Project: Santa Maria Office Building
Addendum Issue Date: March 2, 2026
Bid Date: March 5, 2026 at 5:00 pm
Architect of Record: ATA Architects

Drawing Attachments:

- P100
- P101
- P201
- E002
- E101
- E300

P100

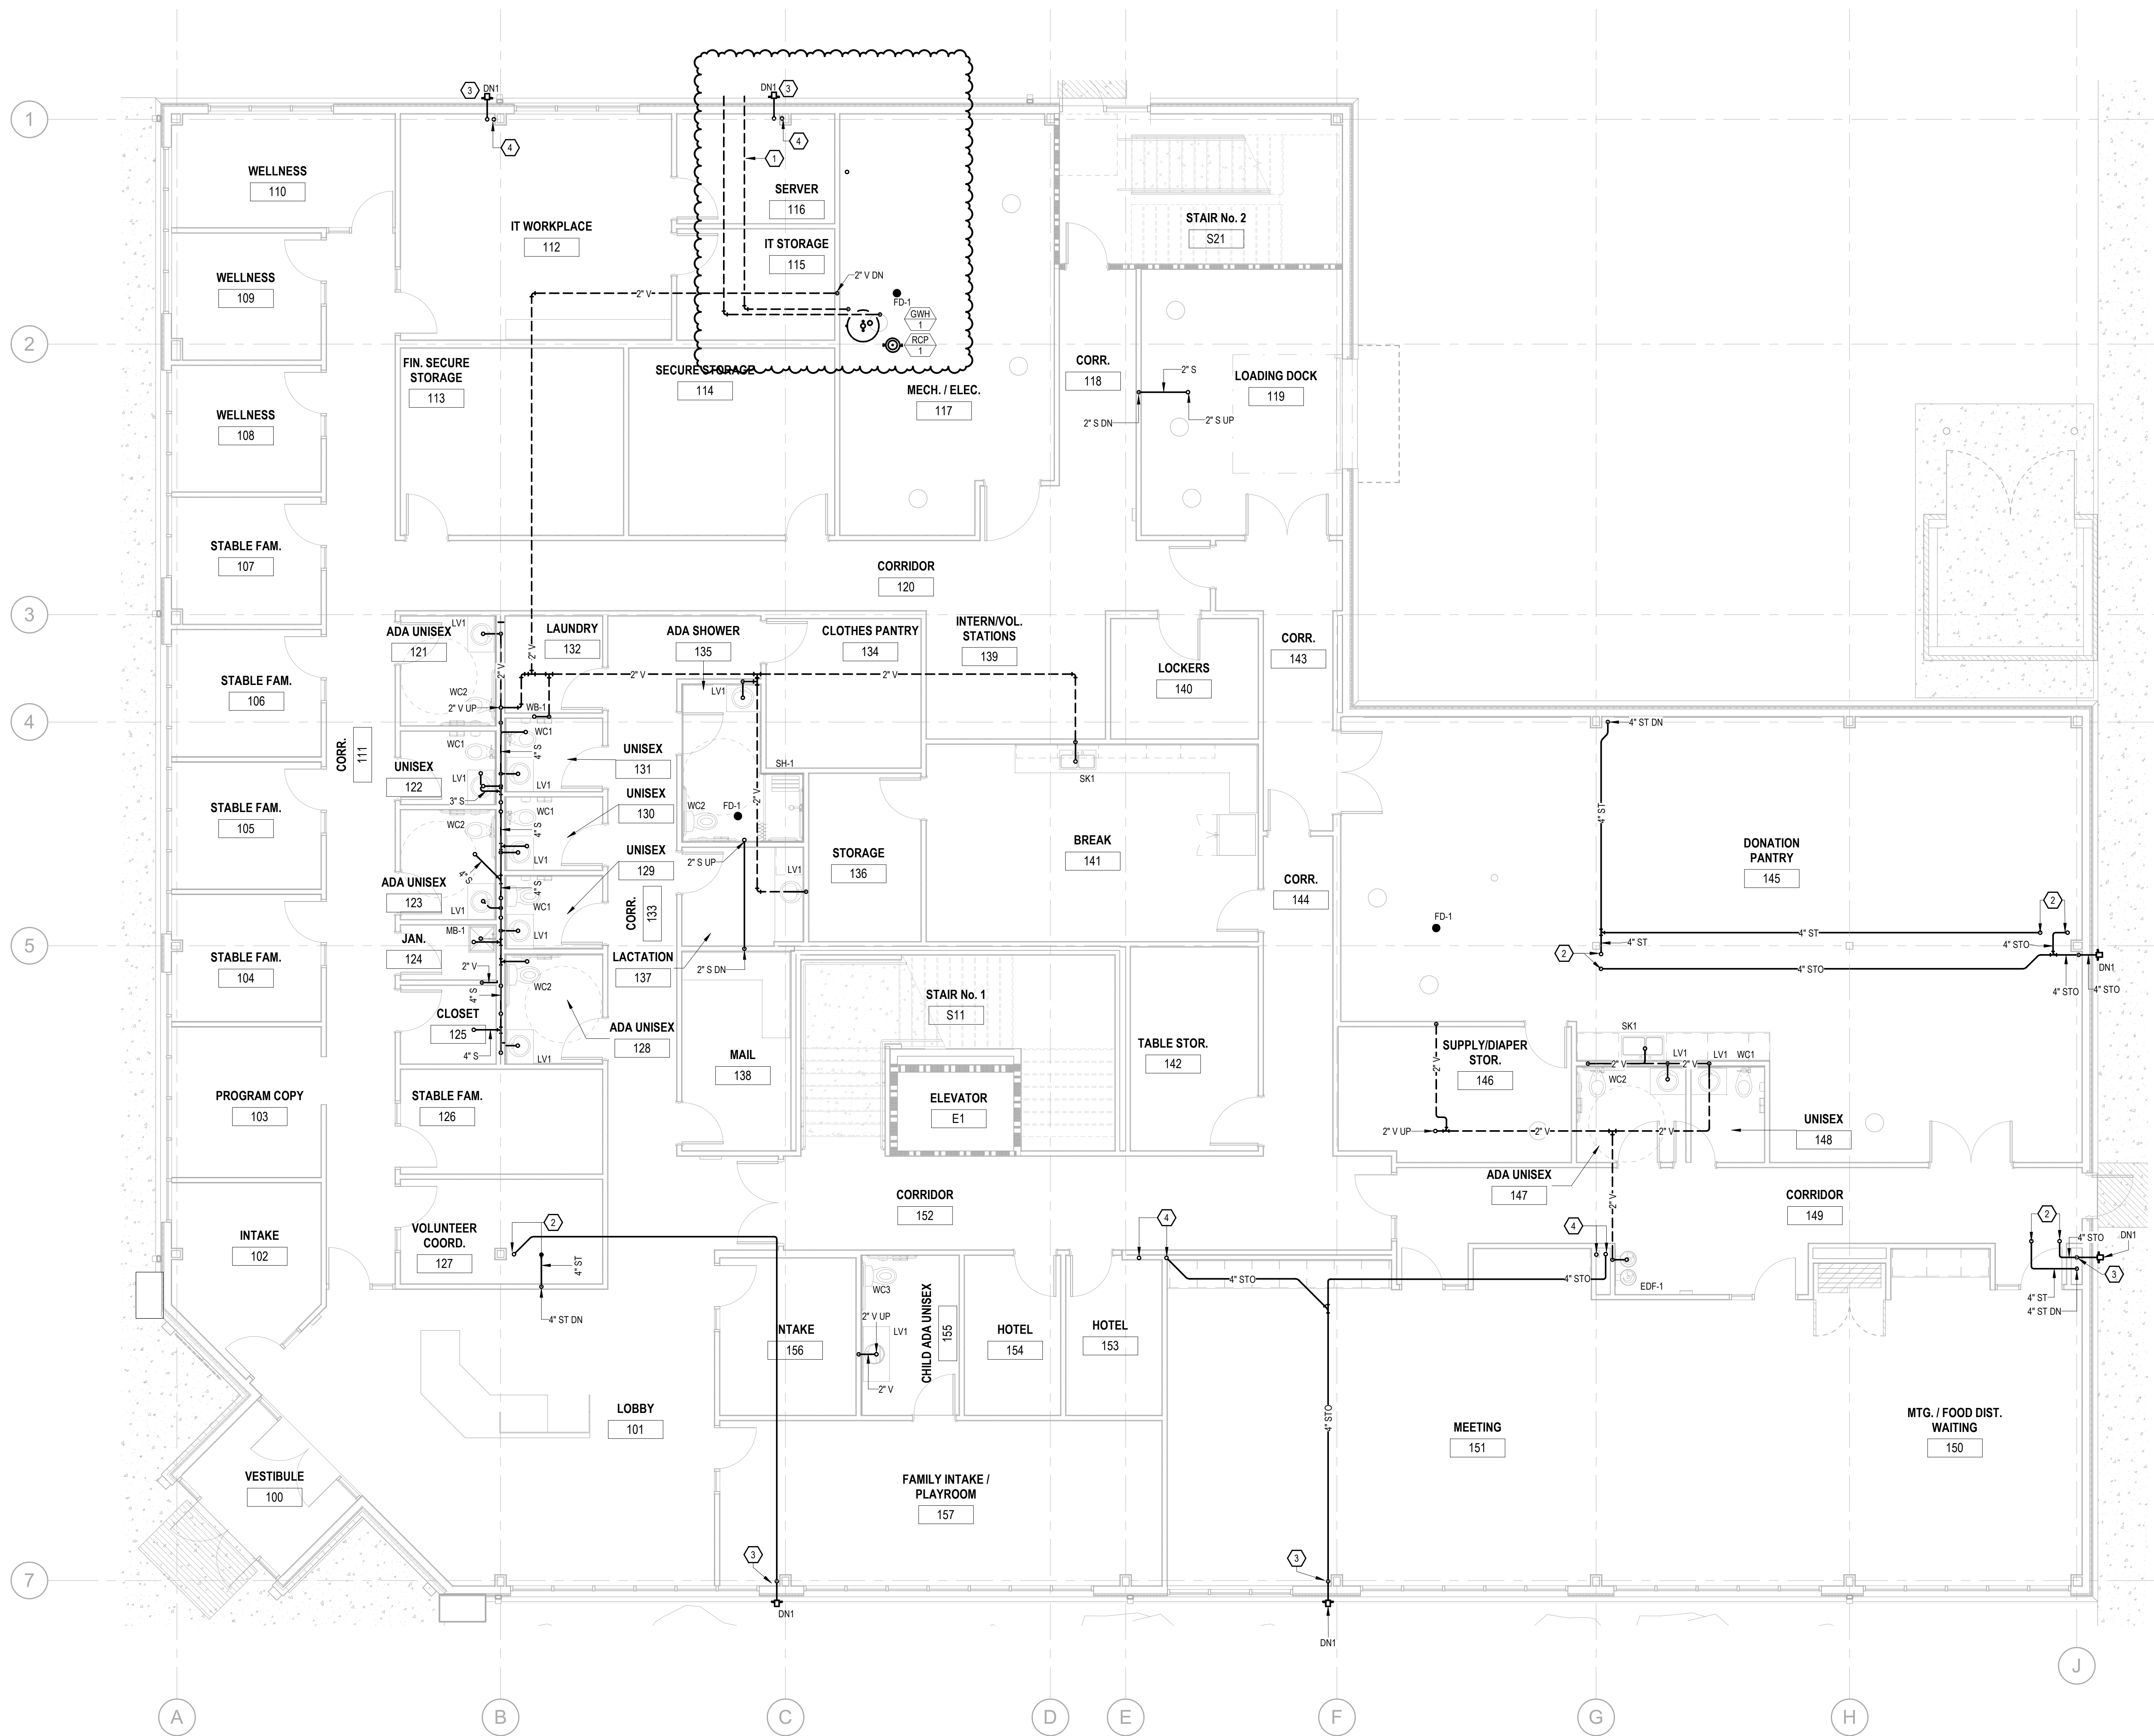
2. At Mech/Electrical Room 117, the water service and electric equipment will need to be coordinated. The water services are currently coming in the building at the same location as Panels H1A and LCP.

- a. Answer – See revised drawings in this addendum.
3. After visiting the site, we noticed the civil drawings appear to show work that has already been completed. (i.e. site clearing, detention pond). Is the phase 2 site work currently out for bid? If so, can we get updated drawings showing what has already been completed?

E002

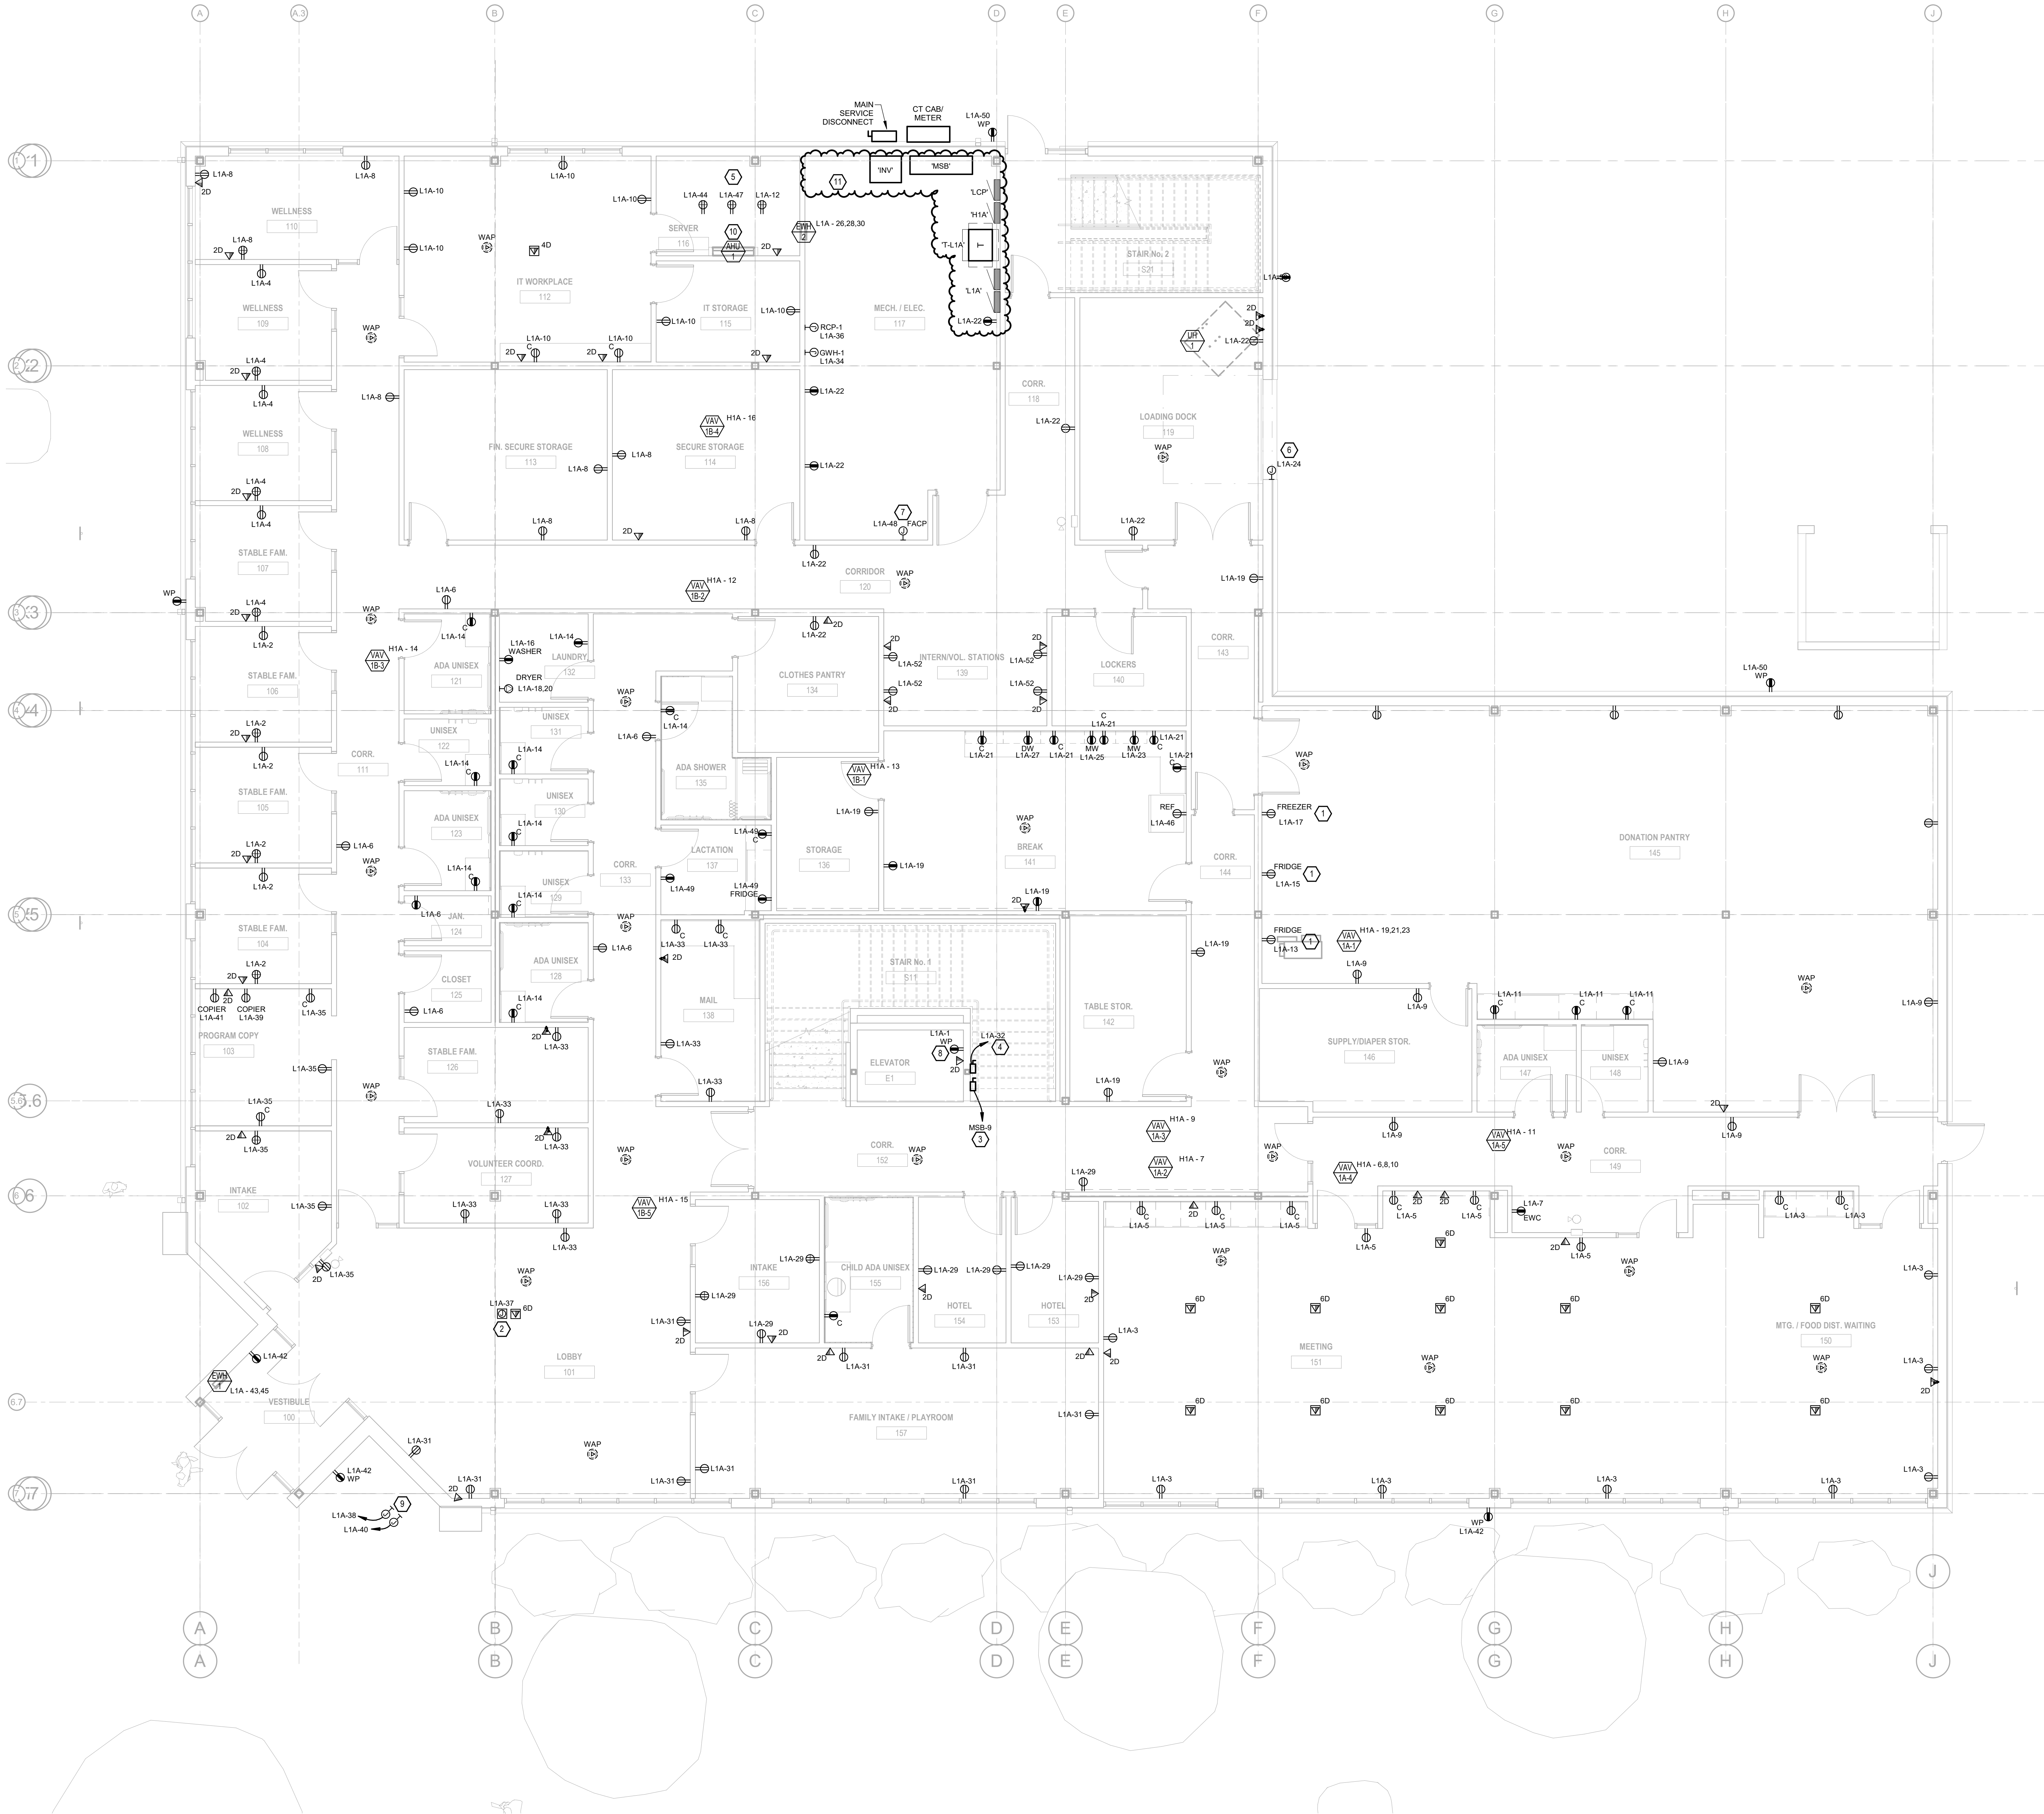
36. Please confirm the specifications for the inverter shown on the drawings. We were unable to locate complete information needed for pricing. We'll need the Manufacturer / model; kVA / kW rating; Input / output voltage; Battery runtime requirements

- a. Answer – Inverter to be Acuity Brands Iota IIIS-3000-277IN-277OUT-FT- " " - 6-1P277-20AMP-ON, or approved equivalent. 3kW rating, 277 in and out, 90 minute runtime.

INVERTER TO BE ACUTY BRANDS IOTA IIS-3000-277IN-277OUT-FT--"- 6-1P27-20AMP-ON, OR APPROVED EQUIVALENT.
